Number: 737-24A1164
Original Issue: October 03, 2007
Revision 3: May 16, 2014
ATA System: 2450

SUBJECT: ELECTRICAL POWER - Electrical Load Distributions - Installation of the Fire Protection Blanket Around the Raceway Wire Bundles

Revision 3 is sent to inform the operators that the Industry Support Information statement is changed, and to divide the service bulletin tasks into configurations for clarification.

**FIGURE 3: RACEWAY WIRE BUNDLES - FIRE PROTECTION BLANKET - REMOVAL
(SHEET 1 OF 3)**

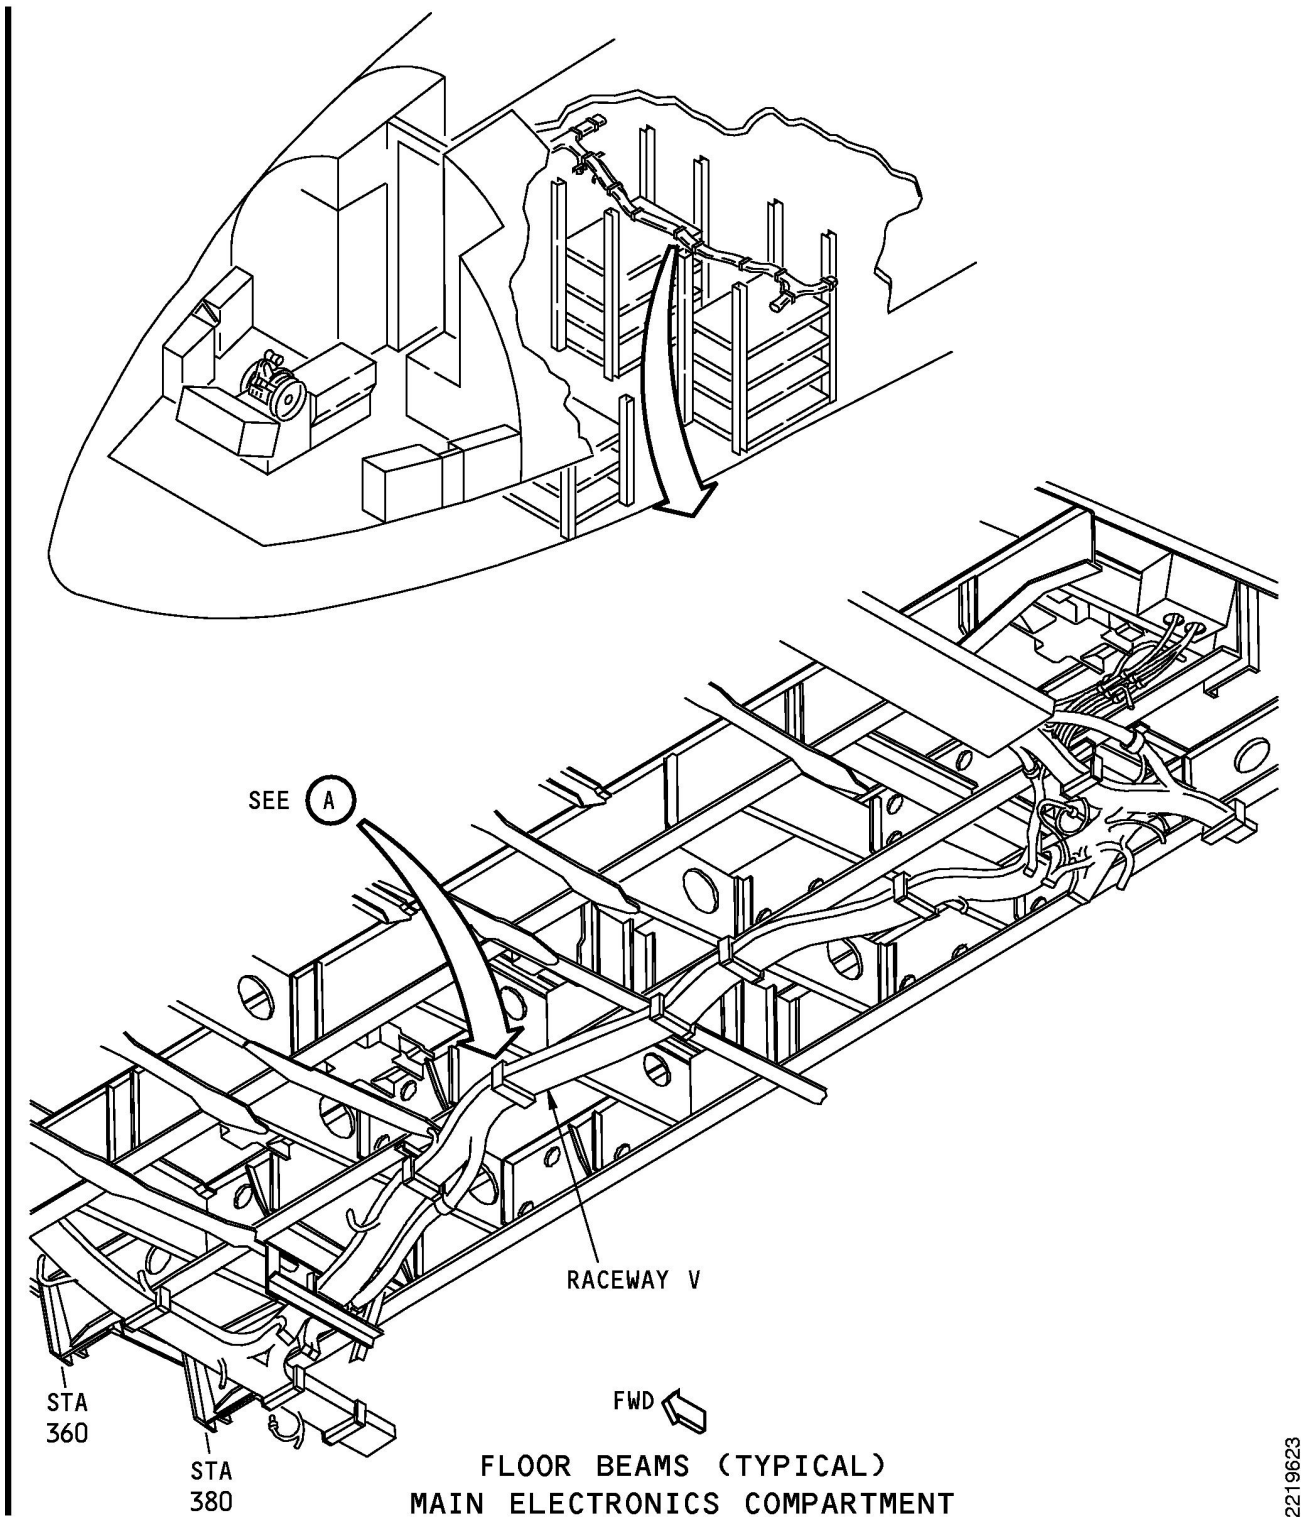
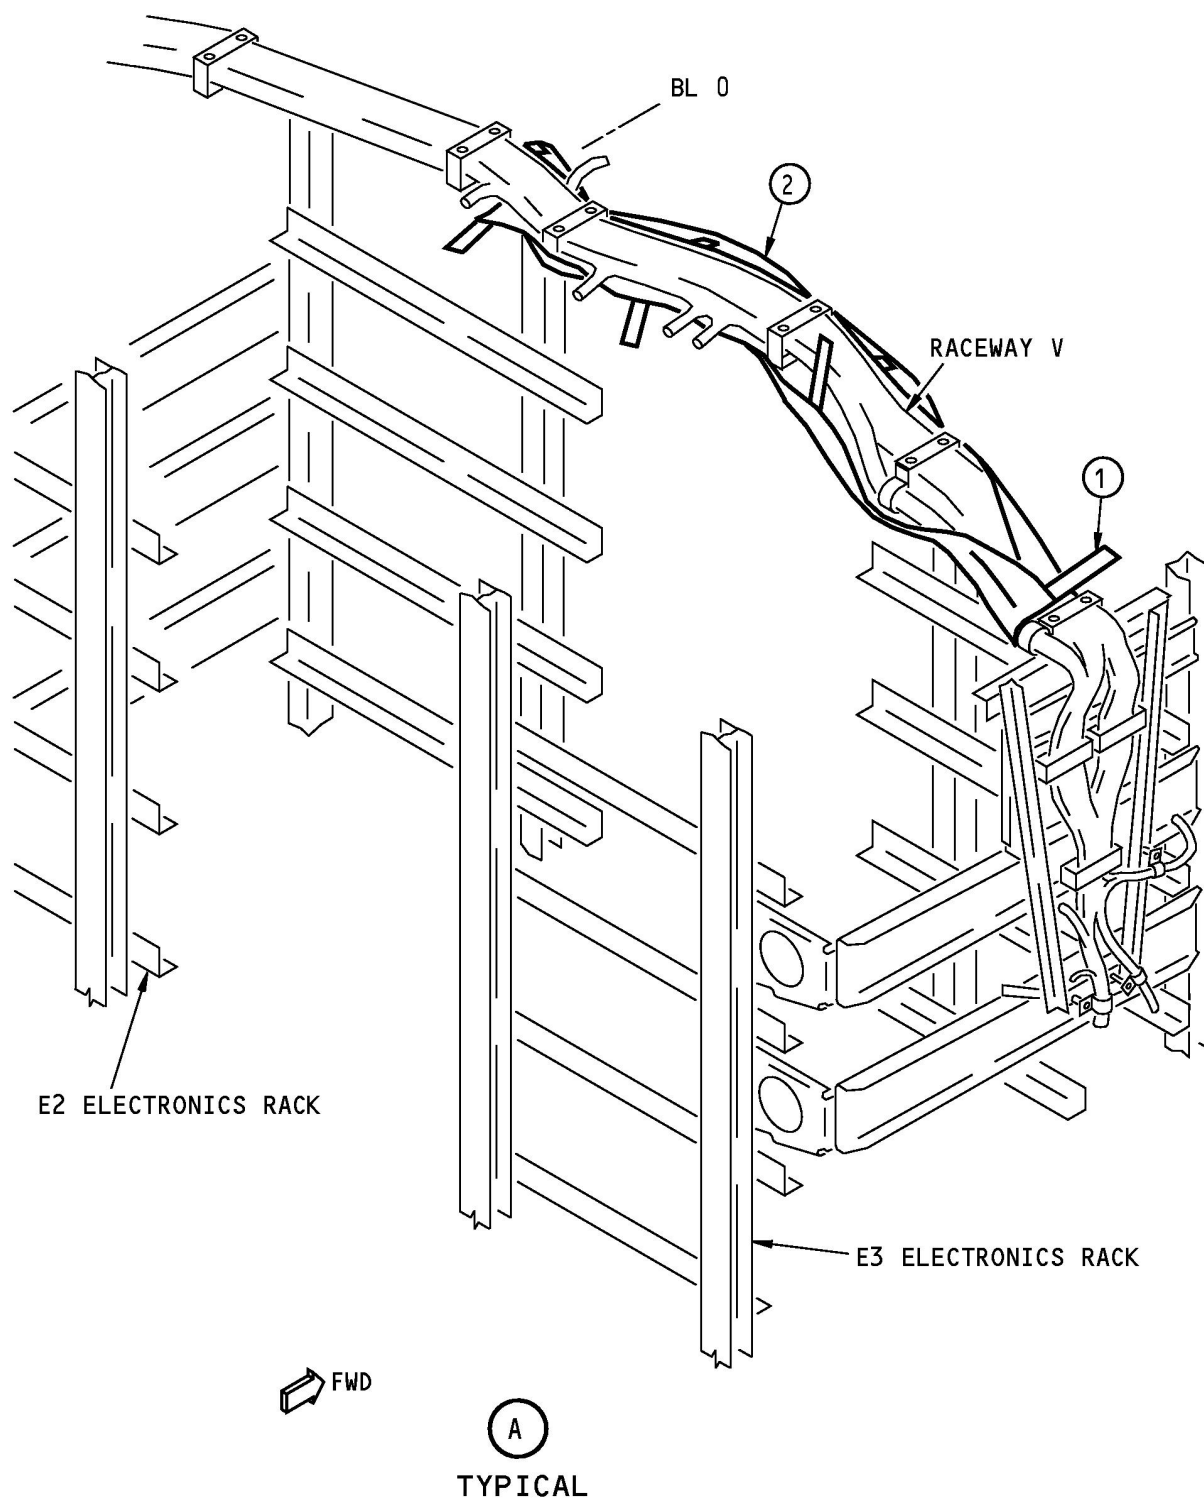
2. Make the changes in the main electronics compartment.
 - a. Above and outboard of the E3 electronics rack, remove the fire protection blanket around the raceway wire bundles in accordance with FIGURE 3.

2. Make the changes in the main electronics compartment.
- a. Above and outboard of the E3 electronics rack, remove the fire protection blanket from around the raceway wire bundles in accordance with FIGURE 3.

STEP	TASK	NAME	IDENTIFICATION	QTY	MORE DATA
1	Remove	VELCRO HOOK	65C38604-5	1	
		VELCRO LOOP	65C38604-6	1	
2	Remove	FIRE PROTECTION BLANKET	65C38604-1	1
